Device	XC866-2FR
Marking/Step	BC
Package	PG-TSSOP-38

This Errata Sheet describes the deviations from the current user documentation. The module oriented classification and numbering system uses an ascending sequence over several derivatives, including already solved deviations. So gaps inside this enumeration can occur.

XC866 User's Manual	V1.2	June 2006
XC866 Data Sheet	V1.0	Feb 2006

**Figure 1** Critical Cases for Power up/ Power down when  $V_{residual} > 500mV$

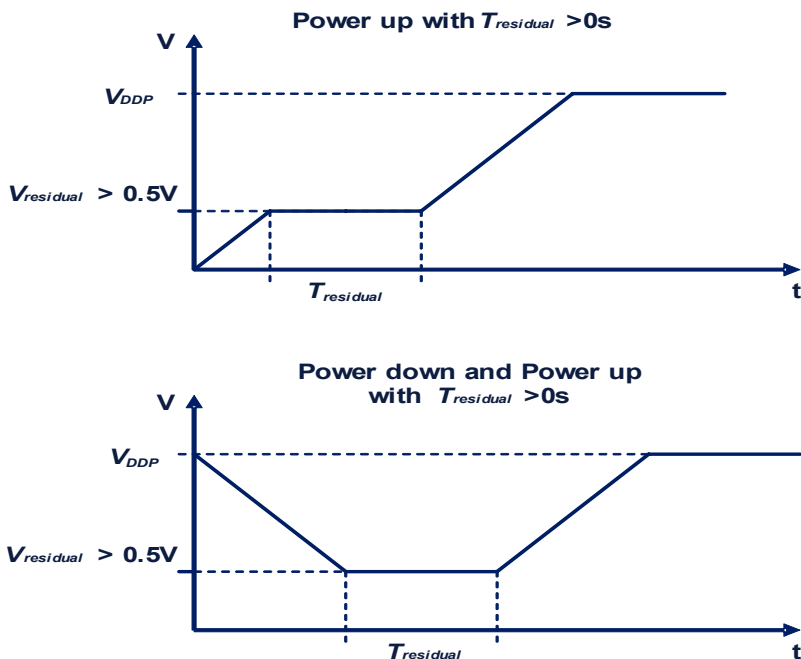
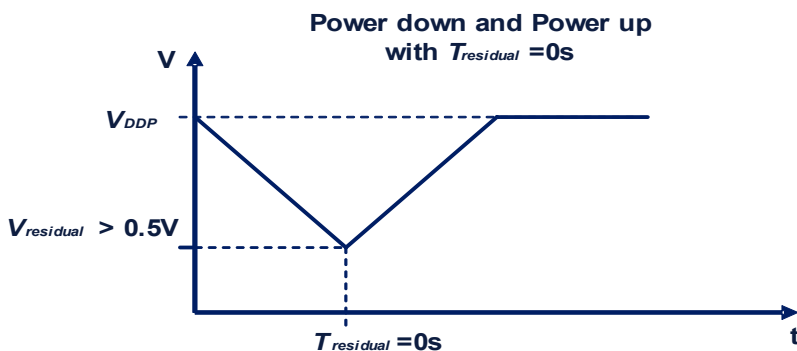
Due to the limitation of the EVR, the reset toggling may occur during the power up. To prevent the reset toggling issue for power up, the following conditions must be met :

1. For power up, the rising time must be less than 2ms/V.
2. The power down time must be more than 0.2ms/V.
3. A permanent  $V_{DDP}$  residual voltage is less than 500mV.

In case of  $V_{DDP}$  residual voltage is more than 500mV, the holding time of residual voltage affects the reset toggling issue. **Figure 1** shows the critical cases for power up/power down when the residual voltages is held for some time. **Figure 2** shows the uncritical case for power up and power down when the power up is triggered immediately after power down. In case of a residual voltage due to immediate power up after power down, the users have to contact IFX to ensure no power up failure.

**Figure 3**

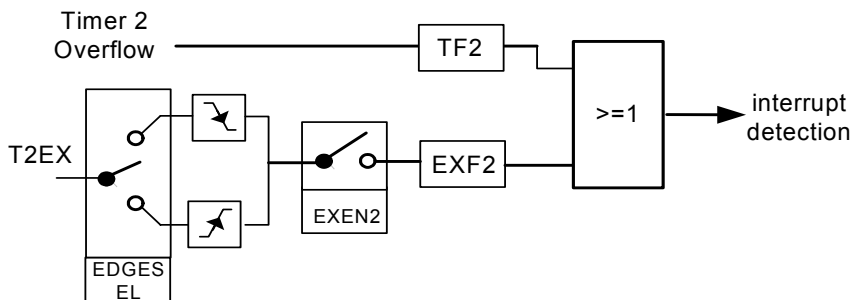
As illustrated in the simplified figure, the Timer 2 interrupt flags TF2 and EXF2 are combined as one interrupt request output. These flags are located within the Timer 2 kernel, with a single interrupt request line as output from the kernel.

**Figure 4**

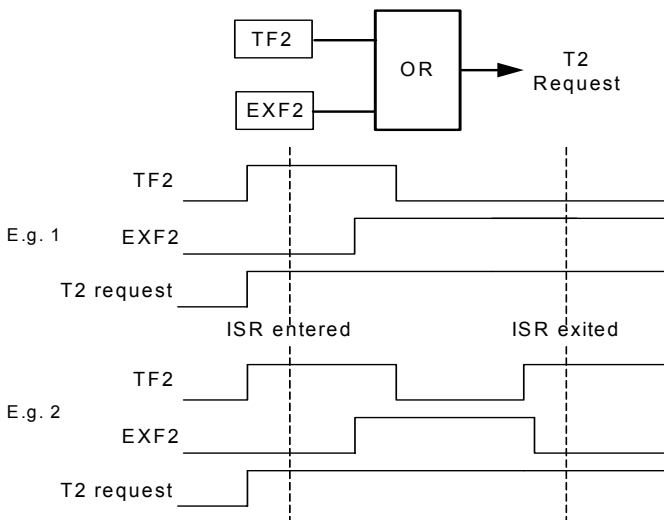
The problem is that it may occur at some point in the application, that any new Timer 2 interrupt request can no longer be detected after a return-from-interrupt (reti) due to service of earlier event(s). This happens when the following conditions are true:

1. Timer 2 events are serviced by interrupt (i.e. flags are checked and cleared only in the interrupt routine ISR),
2. Either TF2 or EXF2 is set at any one time throughout the ISR (even while the other is cleared) such that at least one of the flags is still set after reti, causing the Timer 2 request line, which is an OR-function of the two flags TF2 and EXF2, to remain set throughout the ISR and after reti.

This means, any future Timer 2 TF2 or EXF2 event is not able to cause a rising edge and therefore not able to trigger an interrupt request to the core – as if the Timer 2 interrupts had been disabled, until both EXF2 and TF2 flags are cleared at some time. The clearing of flags would have to be done by user's code additionally outside of the Timer 2 interrupt routine, which is however normally not feasible with an interrupt service scheme.

There is no problem if EXF2 is not enabled by setting bit EXEN2 = 0 i.e. external events are disabled, or if bit DCEN = 1 in auto-reload mode.

Otherwise if EXF2 is enabled, while TF2 is always enabled when Timer 2 is running, there are two suggested workaround:

1. If other events of Timer 2 interrupt node (ET2) need not be enabled for interrupt, disable this interrupt node and use software polling of the flags instead.
2. Before return from interrupt, check again if TF2 or EXF2 is (still) set (due to new request since the last check). If so, jump and execute the ISR routine from start. Exit only when all flags are checked to be cleared. However, dummy interrupt of the node may occur after return from interrupt, and should be ignored. Another drawback is if Timer 2 events are occurring at high rate, the CPU may be 'stuck' in the service routine of the Timer 2 interrupt for a long time.

**Figure 6**

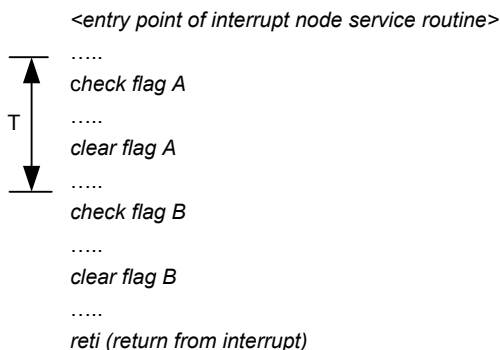
It might occur in the application, that sometimes interrupt requests are serviced, but no active interrupt flags are found. This would happen for those interrupt nodes which is shared by several interrupt sources.

Consider the following interrupt service routine pseudo-code, and scenario where a interrupt source A event leads to interrupt request of the node and CPU vectors to the interrupt routine. Meanwhile, interrupt source B and its flag becomes active any time in the duration indicated by T:

In this case, flag B will be cleared as a standard procedure by the interrupt routine in the current service of the interrupt node. However, the pending

interrupt request for the node remains activated after RETI, as it is only cleared by hardware when CPU acknowledge the interrupt and vectors to the interrupt routine.

This leads to following servicing of the interrupt node again, but potentially no active flag is found, i.e. dummy interrupt service. The point to note is that the interrupt source B is not lost, as it was actually serviced in the current service of the interrupt node.

The recommendation is to ignore these dummy interrupt vectoring.

**Figure 7**

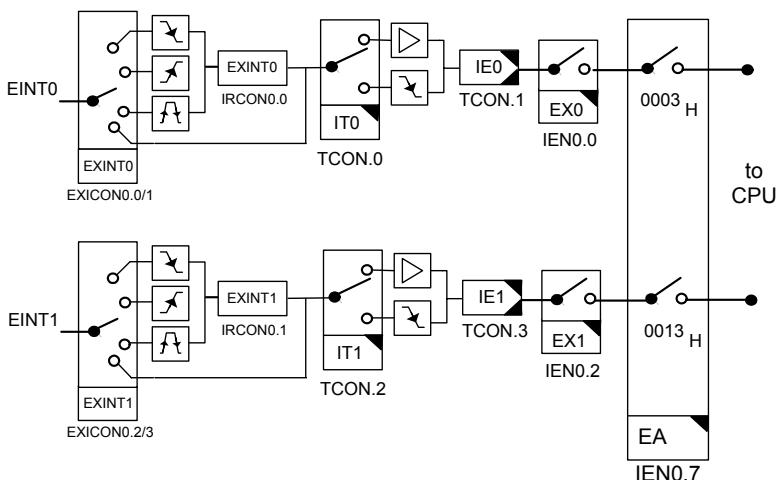
External interrupt 0 and 1 may individually be selected via respective bits ( $EXINTx$ ) in  $EXICON0$  register, to request interrupt on falling edge, rising edge, both edges or to bypass the edge detection.

Edge detection is done in the system unit. If enabled, an active event will set the  $EXINTx$  flag and correspondingly set the  $IEx$  flag in  $TCON$ . It should be noted that after any external interrupt  $x$  event, flag  $EXINTx$  must be cleared. In case of falling edge as active event, this allows any future active event to be able to set the flag  $IEx$  as interrupt request. In case of low level as active event, this prevents unintended recurring triggering of interrupt request.

In case of bypass edge detection, the input is connected directly to the core (bypass the system unit). The flag  $IEx$  in  $TCON$  will be set on the selected falling edge or low level (at least 2 clock cycles) event. In case of falling edge selected as active event by  $TCON.ITx$ , the flag  $EXINTx$  is set in addition to the flag  $IEx$ . However to use this mode properly, user must not clear the flag  $EXINTx$  and if necessary, to only access the flag  $TCON.IEx$  (refer to INT\_XC8.003).
